Addendum to
PowerPC 604[™] RISC Microprocessor User's Manual:

PowerPC 604e[™] Microprocessor Supplement and **User's Manual Errata**

This addendum to the PowerPC 604 RISC Microprocessor User's Manual is in two parts:

Figure 8-20. Burst Transfers with Data Delay Controls

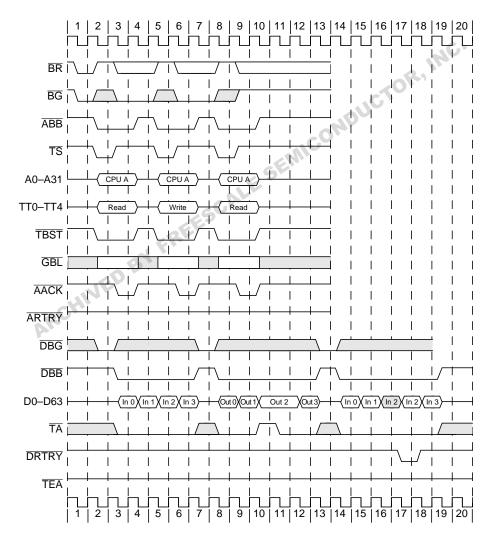
8.5, Page 8-36 Replace Figure 8-20 with the following:

Figure 8-21. Use of Transfer Error Acknowledge (TEA)

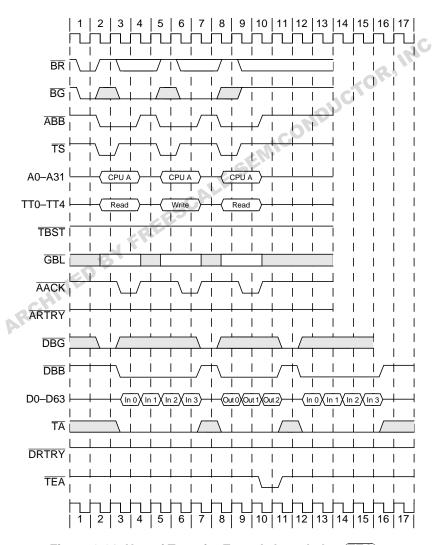
8.5, Page 8-37 Replace Figure 8-21 with the following:
